Consumers
Power
Company

February 5, 1976

MIDLAND PROJECT
DOCKET NUMBERS 50-329, 50-330
REGULATORY GUIDE IMPLEMENTATION
FILE: 0505 SERIAL: 2133

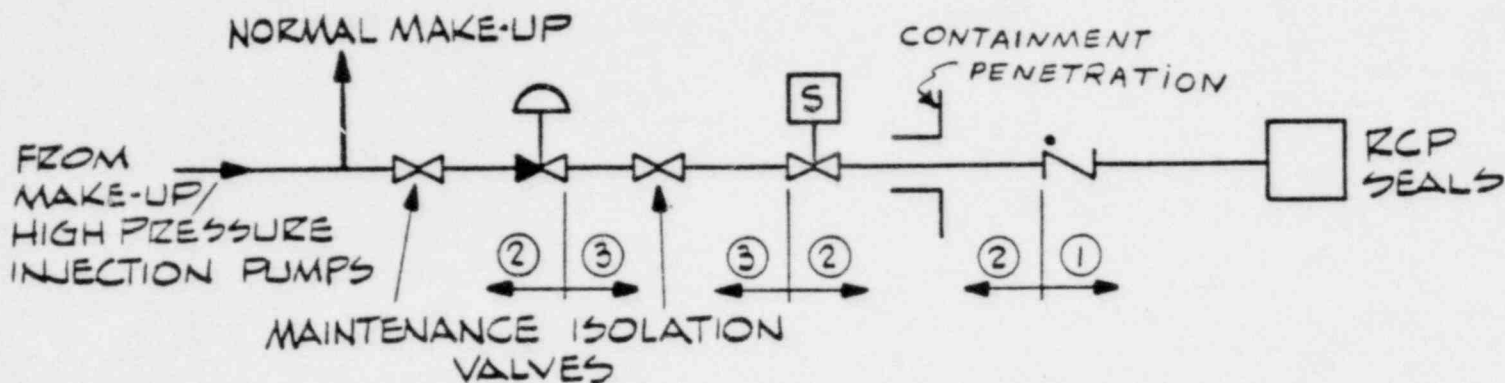
211.2

Identify those portions of the Makeup and Purification System that provide seal injection cooling water to the reactor coolant pumps and are constructed to ASME Section III, Class 3 and Seismic Category I requirements.

The following schematic diagram shows the piping class configuration of the seal injection system:

- 1 - ASME Section III Class 1 and Seismic Category I
- 2 - ASME Section III Class 2 and Seismic Category I
- 3 - ASME Section III Class 3 and Seismic Category I
